## REPLACEMENT OF WELDED TUB AND COUNTERWEIGHT

The welded tub part no. 126 85 72-30/0 is not available as spare part anymore.

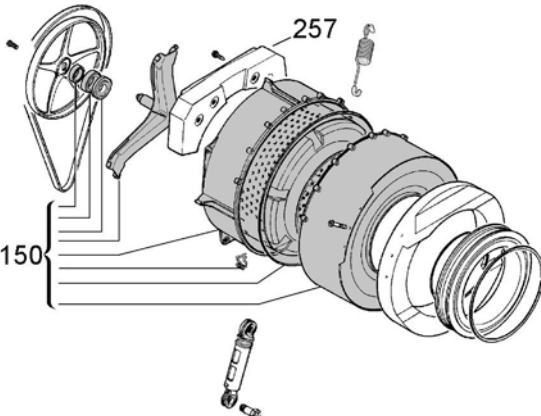
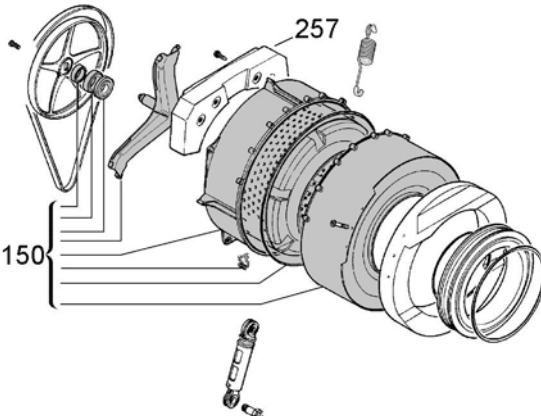
As a replacement a welded tub part no. 126 85 75-00/6 is supplied.

**Simultaneously it is obligatory to replace also the rear counterweight.**

Pos.	Description	Part no.	Pos.	Description	Part no.
150	Welded tub assembly	<b>Depleted</b>	150	Welded tub assembly	<b>126 85 75-00/6</b>
257	Rear counterweight	<b>126 05 19-00/2</b>	257	Rear counterweight	<b>126 05 19-50/7</b>
